Lower Thames Crossing TR010032

Responses NH submissions at D4

Thames Crossing Action Group

DEADLINE 5 (3rd October 2023) / Submitted 3rd October

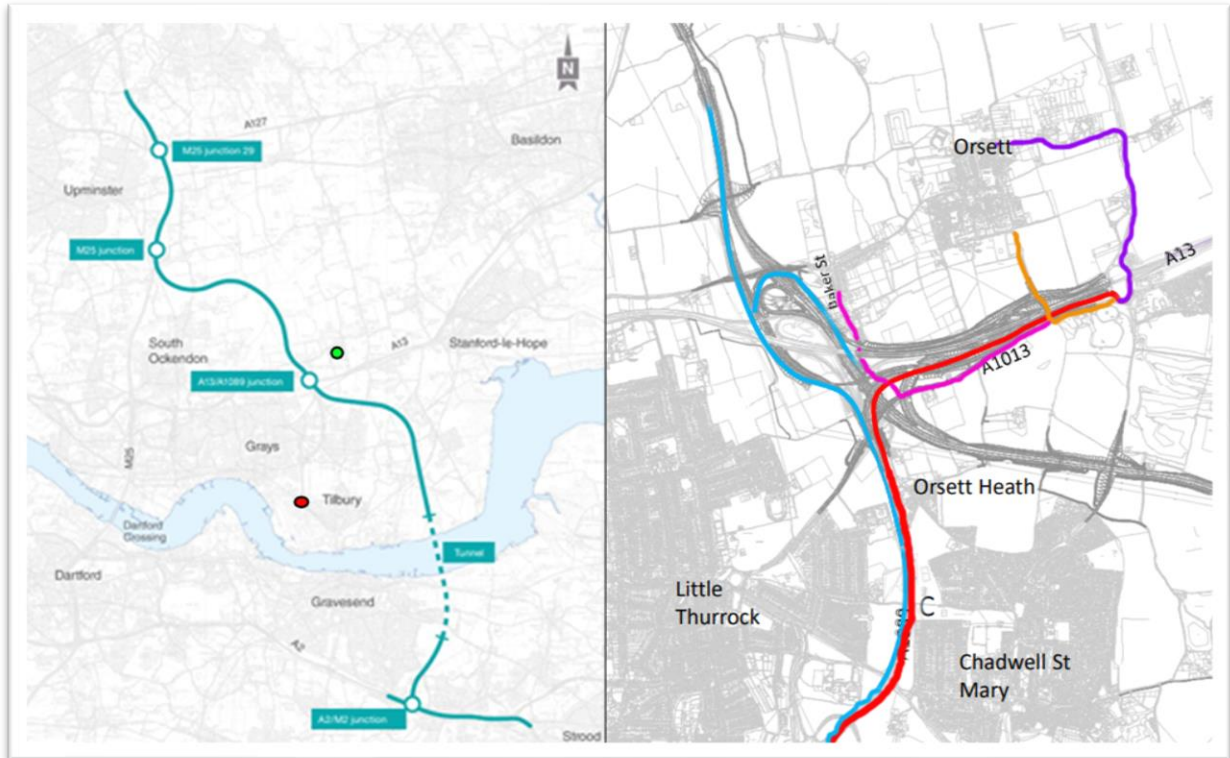
20. The local journeys to and from the proposed LTC that are set out in the signposted document are selective and limited on showing the true extent of the journeys local traffic would need to take to join the LTC.

21. For example, from Orsett to join the LTC traffic would have to leave Orsett either via Prince Charles Avenue (shown in purple on the map below), via Rectory Road (shown in orange on the map below), via Baker Street (shown in pink on the map below). Each would take the traffic to the Orsett Cock where it would then take the exit as though going to the A13 westbound, and take the A1089 slip road off of the slip road that would join the A13 westbound. It would then need to travel southbound on the A1089 to the Asda roundabout (shown in red), and then u-turn and head back north on the A1089 to join the LTC (shown in blue).

22. The map to the left in the image below shows Orsett (green dot) and Asda roundabout (red dot) to show the extent of the journey distance, since the Asda roundabout is not shown on the map on the right.

B.6.4 Local journeys to and from the A122 LTC are set out in Visual Representation of A13/A1089/LTC Intersection for ISH3 [\[AS-146\]](#). Local traffic wishing to access the A122 LTC could do so via the A1089 (which connects to LTC northbound and southbound) or via the A13 from the east.

D.8.1

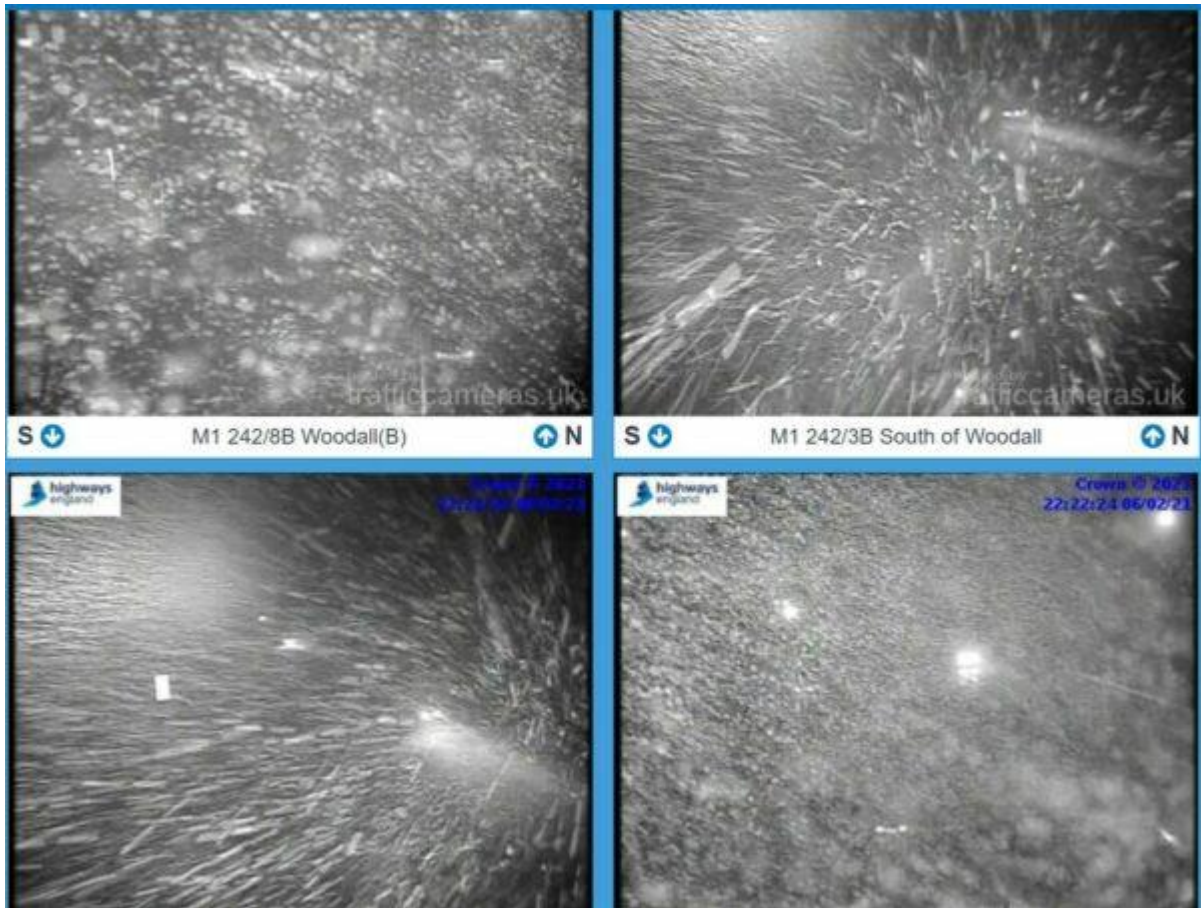
33. This comment appears to show that NH do not deny that there would be fog and high winds across the Mardyke Valley, as we have stated and voiced concerns about on numerous occasions.

34. We fail to see how technology such as variable message signs will solve the problems and address the concerns we have. The fog will still reduce visibility, and high winds will still cause issue for vehicles, particularly higher sided vehicles such as HGVs.

35. There are also concerns about the fact there would be no hard shoulder, so when there are incidents where would road users find safe refuge?

36. The images below are what the 'smart' tech sees when it is snowing, and equally visibility would be greatly reduced when there is fog, thus putting road users at extra risk. These cameras are also often pointing away from where they should be focused and one reason for that can be due to high winds moving the camera's position.

D.8.1 In response to comments raised by Thames Crossing Action Group, the design of the project will include technology such as variable message signs which can advise caution and give instructions in the event of fog or high winds.
